DEVELOPMENT ASSESSMENT CASE NUMBER: CD-2014-0010

Presentation of a Development Assessment Report for Austin Oaks Planned Unit Development (PUD), located at the southwest corner of Spicewood Springs Road and Mopac Expressway, within the Shoal Creek Watershed.

AUSTIN OAKS PLANNED UNIT DEVELOPMENT Development Assessment Staff Review Comments

LAND USE PLAN

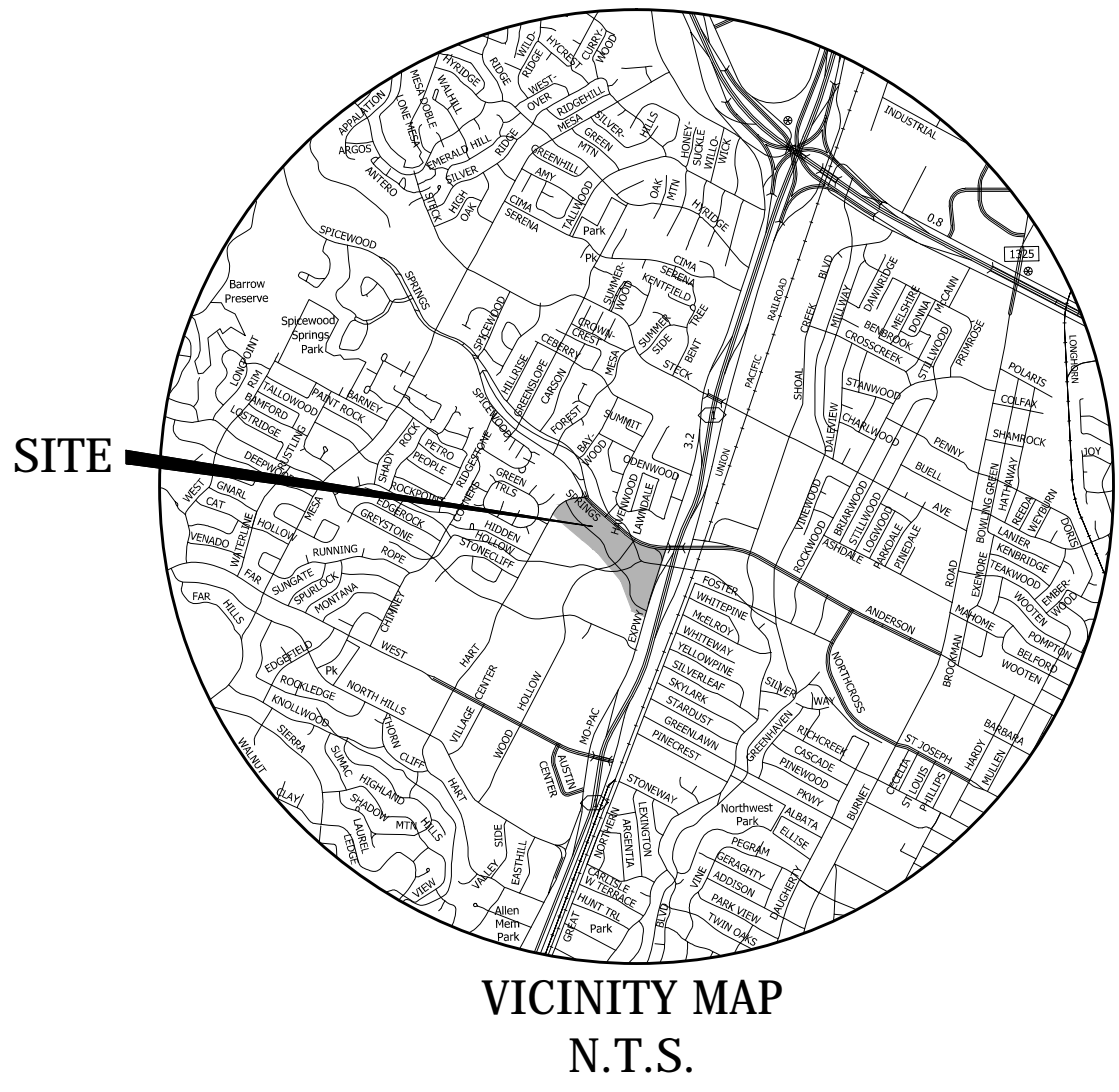
1. Portions of Area C & F are located with the 100-year floodplain.
2. If a construction element application is sought, applicant will be required to comply with current floodplain regulations including restrictions of constructing buildings or parking within the limits of the 100-year floodplain, containing the floodplain within an easement and all other floodplain regulations found within the Land Development Code.
3. Changes to the existing parking lot in Area C located within in the floodplain cannot increase the existing non conformity of the existing development. For example, a restriping of the existing lot which increases the number of existing parking spaces in the floodplain would not be allowed.

The summary letter PUD Requirement chart (page 2 of the letter) should be changed to remove the reference to Alternative Equivalent Compliance for sidewalks. Also remove the reference to Alternative Equivalent Compliance for sidewalks on the Land Use Plan. The Tier 1 & 2 Compliance Chart clearly states that Core Transit Corridor sidewalks will be provided as required – place that note on the Land Use Plan.

4. Tier Two requirements: Where is the 25% open space located? Either each site plan must provide 25% independently, or the PUD land use plan must show the location of the open space.
5. Art – Provide documentation from the Art in Public Places office concerning this requirement. There is currently no method in which to enforce this requirement, and the AIPP office has requested additional input prior to a PUD choosing this option from Tier Two requirements.
6. Community Amenities – Show the location of the proposed community meeting space on the PUD land use plan.
7. It is not clear why the 1st floor cannot contain pedestrian oriented uses.
8. Clarify the exact amount and percentage of affordable housing proposed for this PUD.

1. Streets should comply with The Great Streets Program in areas B, C, D, E, and F of the proposed PUD (2.4).

2. Please provide information as to the rationale of the proposed height, which varies by tract.
3. Please provide more detail on the distribution of uses, and mixes thereof, throughout the site. For example, if a PUD tract is labelled "multifamily" is it only multifamily, or predominantly such? Provide more information on a per-tract basis, and per building, if possible.

9. Will driveways/curb cuts remain or be relocated?
10. Please provide all required information on the land use plan (e.g., existing land uses/zoning).
11. Please identify open space(s) on land use plan.
